# HISTORIC AND DESIGN REVIEW COMMISSION

**HDRC CASE NO:** 2020-252  
**ADDRESS:** 328 E JOSEPHINE  
**LEGAL DESCRIPTION:** NCB 975 (BOEHLER'S SUBD), BLOCK 18 LOT 15  
**ZONING:** C-3, RIO-2  
**CITY COUNCIL DIST.:** 1  
**APPLICANT:** Kristen Weber/Don B. McDonald, Architect  
**OWNER:** RIO PERLA PROPERTIES LP  
**TYPE OF WORK:** Amendments to a previously approved design, new construction, site work  
**APPLICATION RECEIVED:** June 12, 2020  
**60-DAY REVIEW:** Not applicable due to City Council Emergency Orders  
**CASE MANAGER:** Edward Hall  
**REQUEST:**

The applicant is requesting a Certificate of Appropriateness for approval to amend a previously approved design. Within this request, the applicant has proposed the following:

1 Boehler's Bar Roof Plan

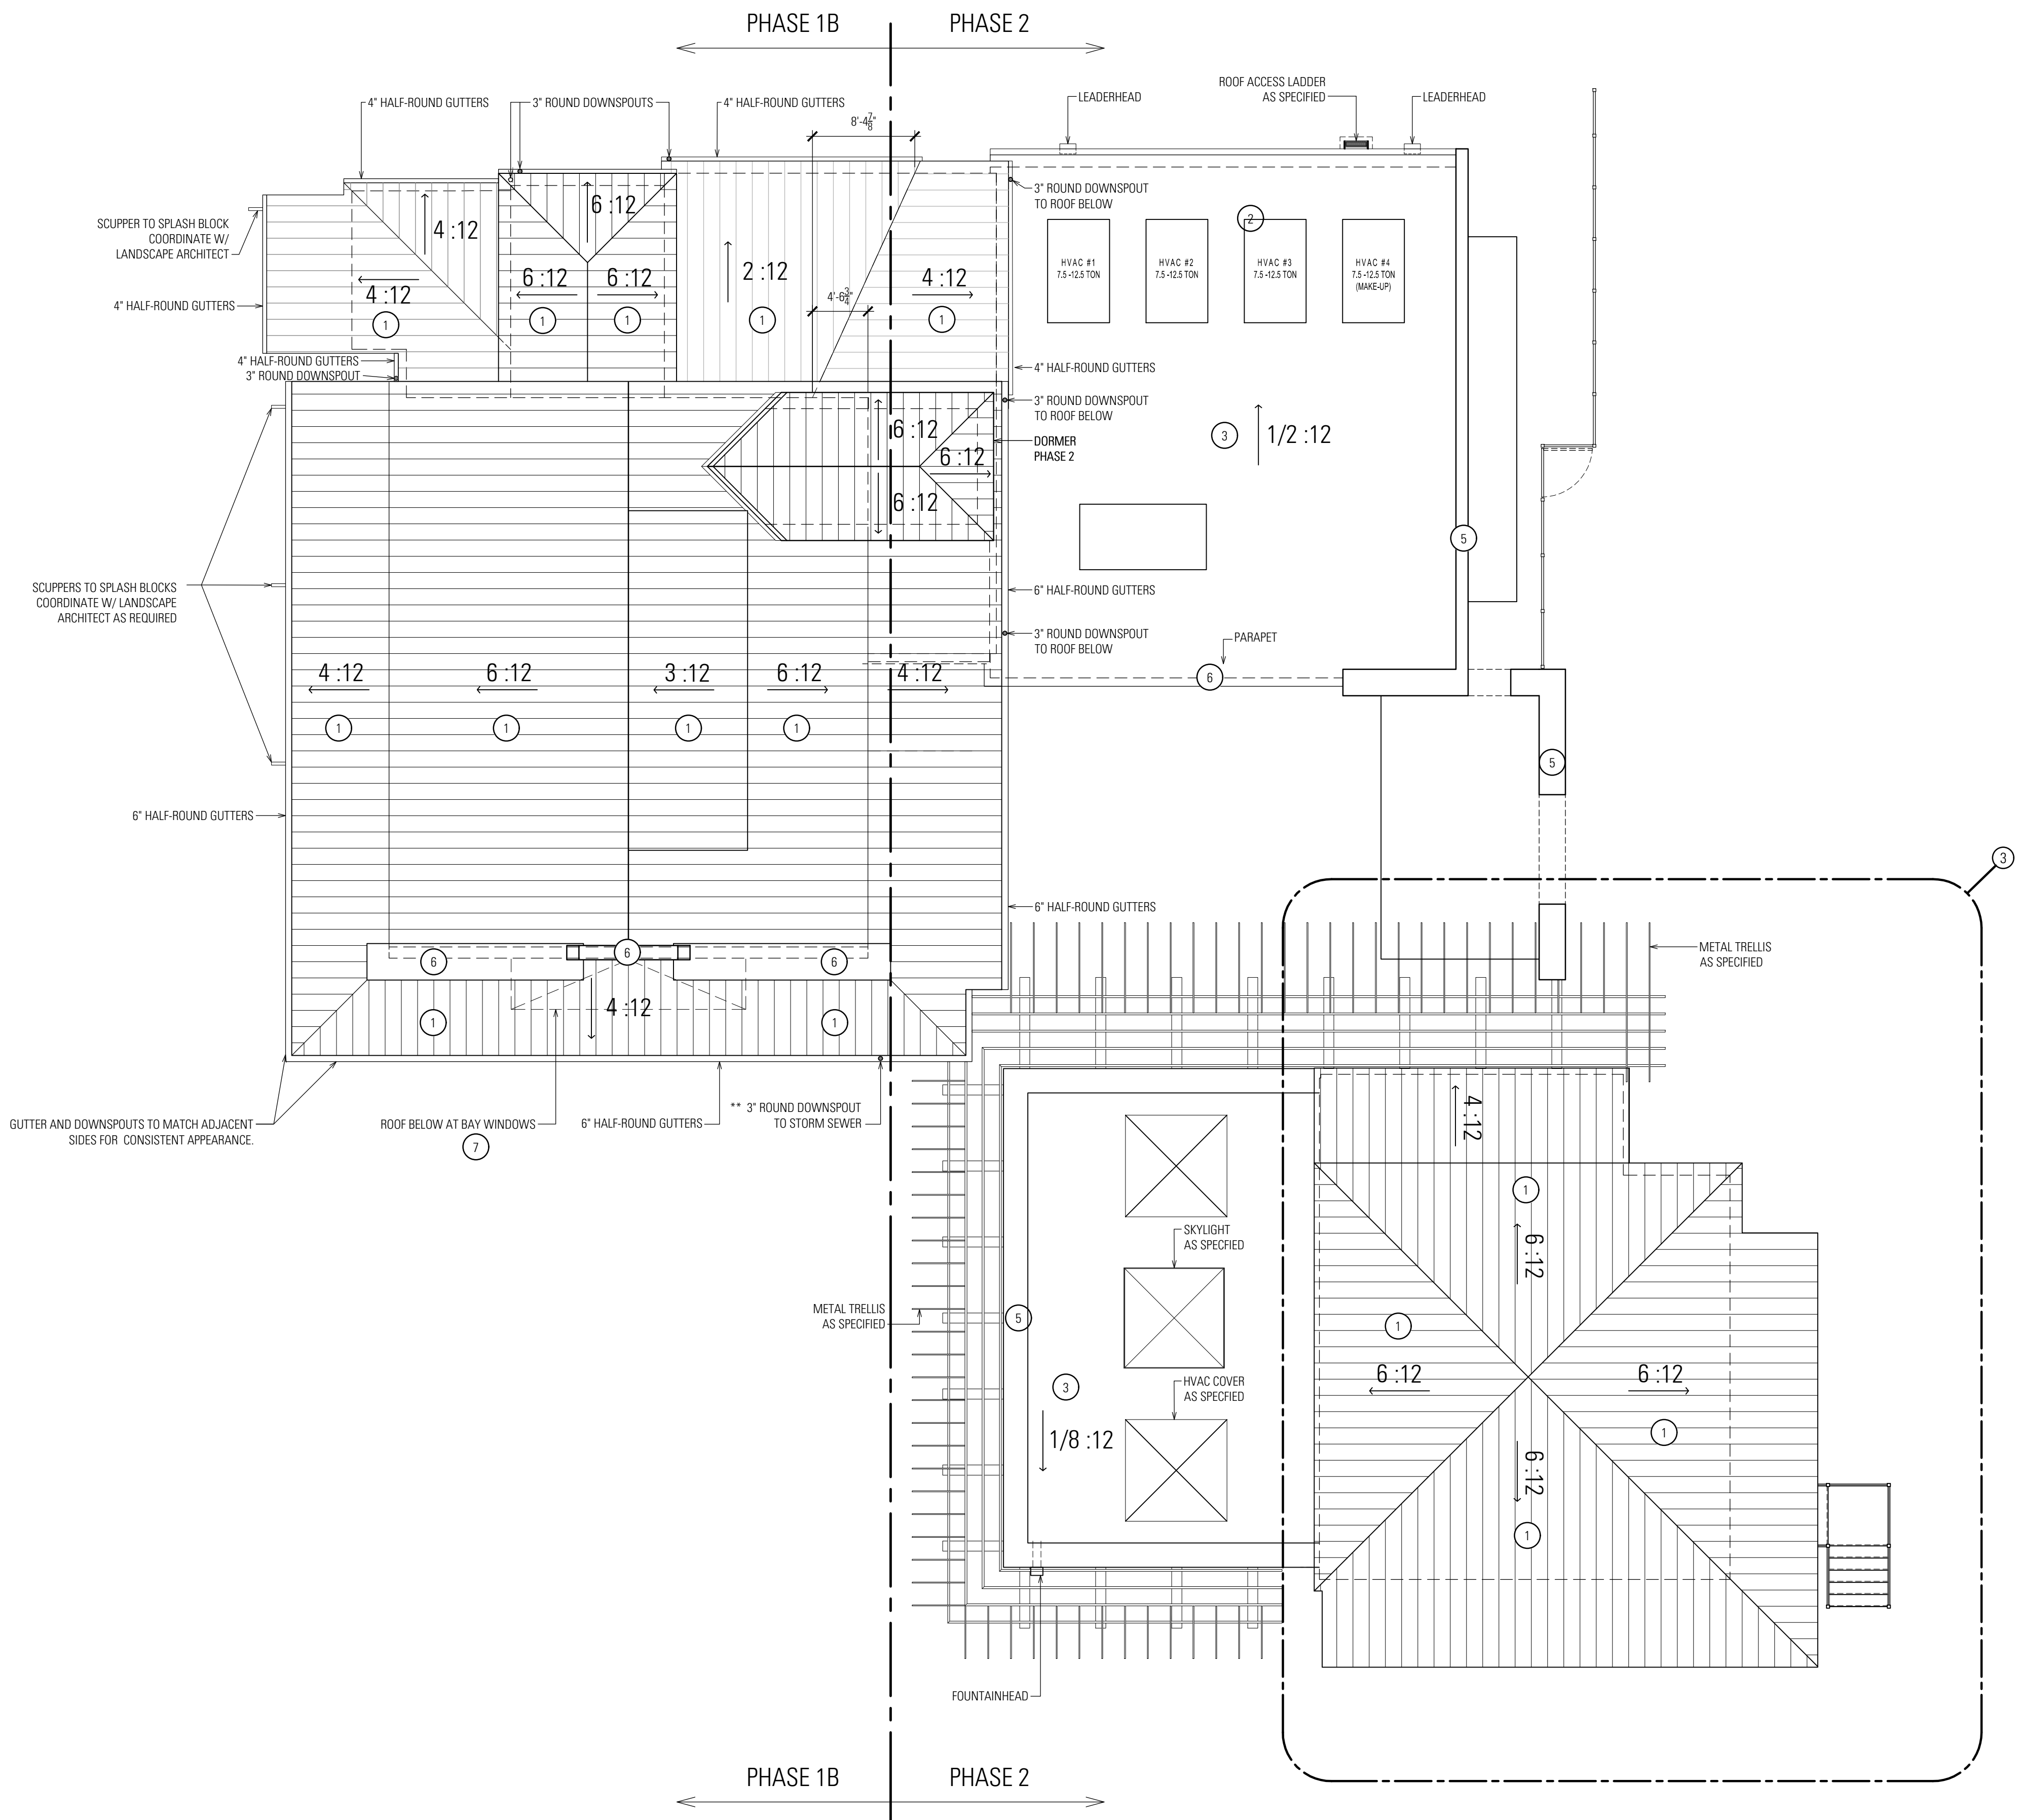
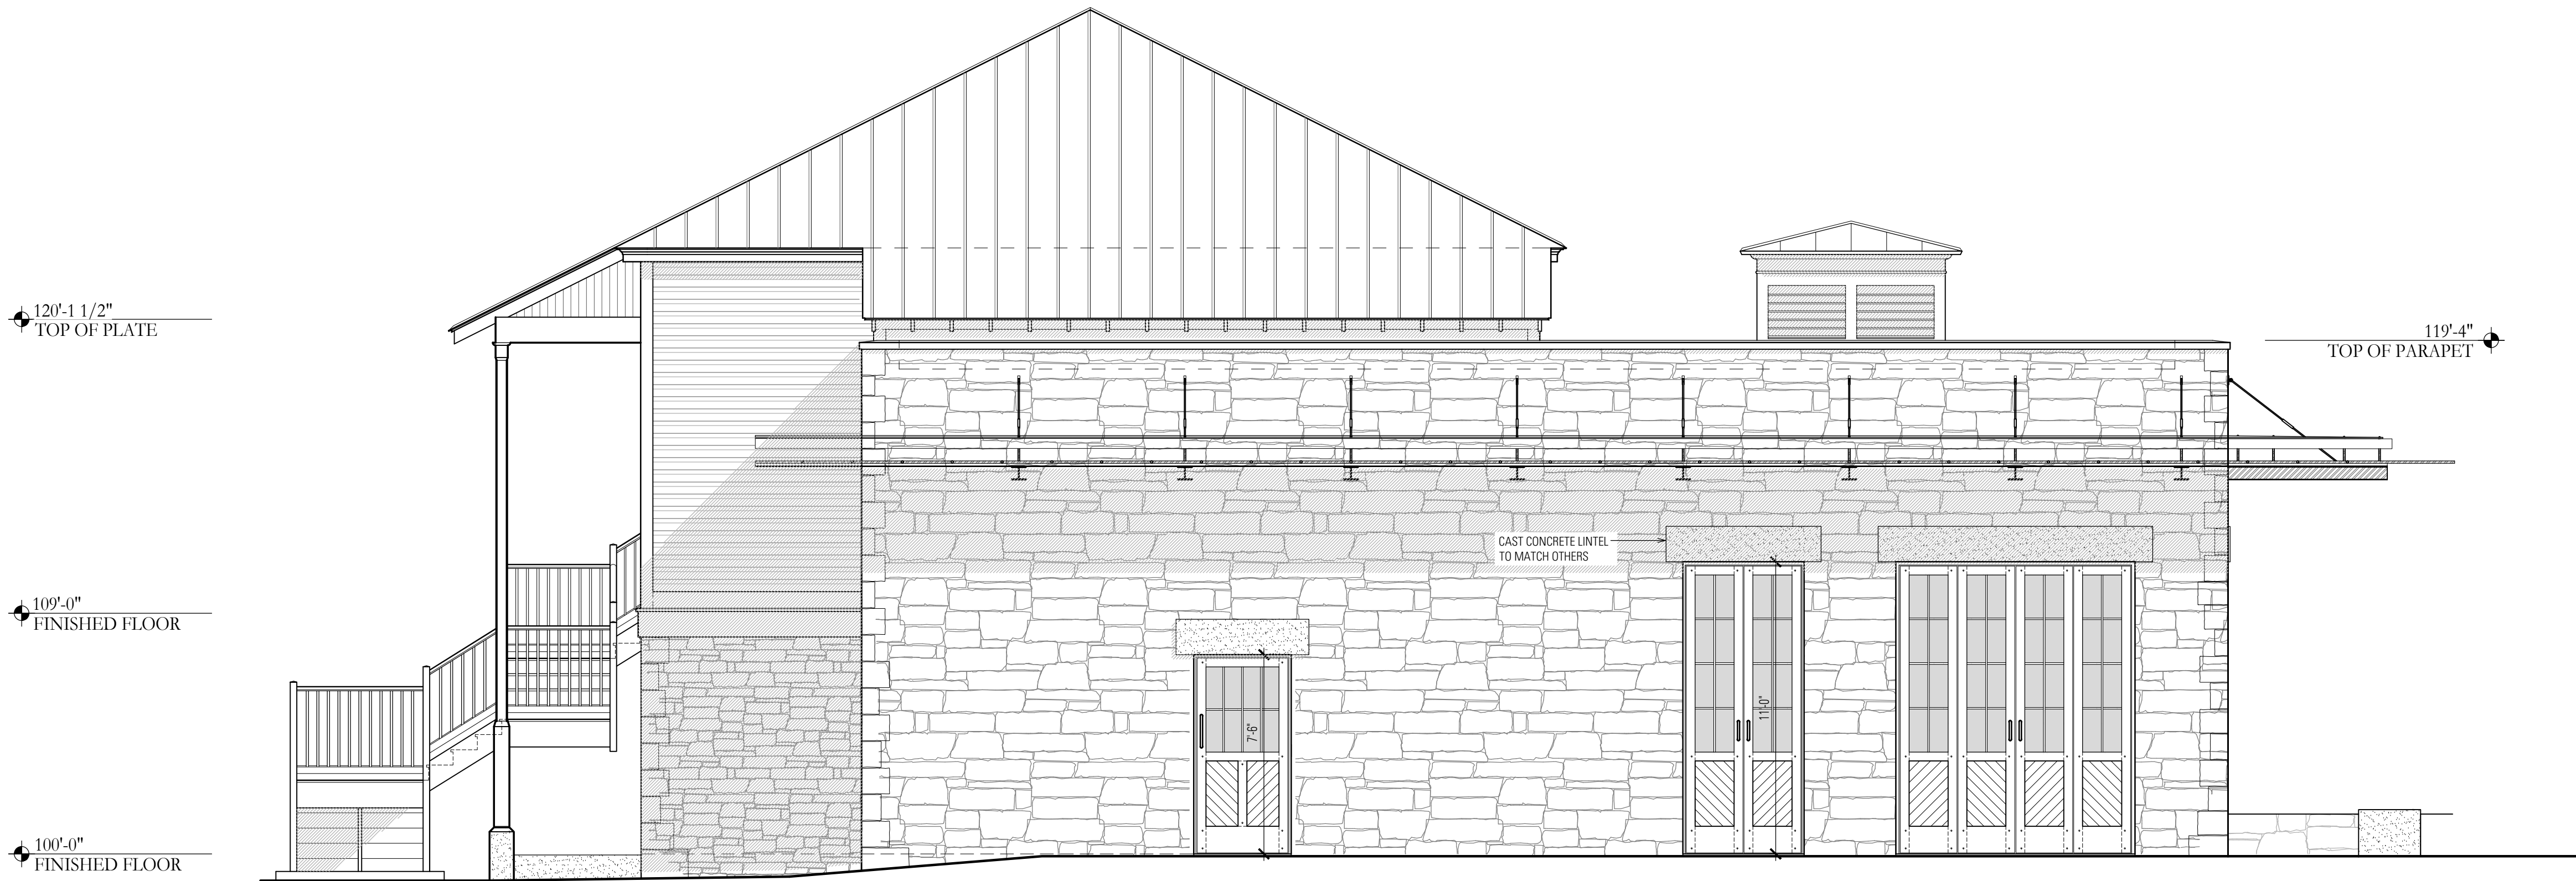
3. Construct a restaurant structure utilizing the doors, windows, exterior materials, chimney brick and interior siding of the Boehler's House, where feasible. The Boehler's House will be demolished.

- d. NEW CONSTRUCTION – The applicant has proposed to construct a new restaurant structure to replace the existing structure, commonly known as Boehler's House. The applicant has proposed to demolish Boehler's House, and to construct a new structure using the doors, windows, exterior materials, chimney brick and interior siding of the Boehler's House, where feasible. The Boehler's House is not a designated historic property and is eligible for demolition. If the HDRC approves the request as proposed, a demolition permit will be issued administratively by staff.

The initial plan to raise and restore Boehler's House proved to be too inefficient and costly. The new plan is to salvage all Doors, Windows, Exterior, Chimney brick and Interior Siding where possible. Rather than recreate a replica of the generic cottage, the new proposal utilizes the salvaged materials to create a structure that speaks directly to the San Antonio raised cottage vernacular. Equally important, a long narrow porch overlooking Avenue A reinforces the character of the street when Boehler's stood at the corner.
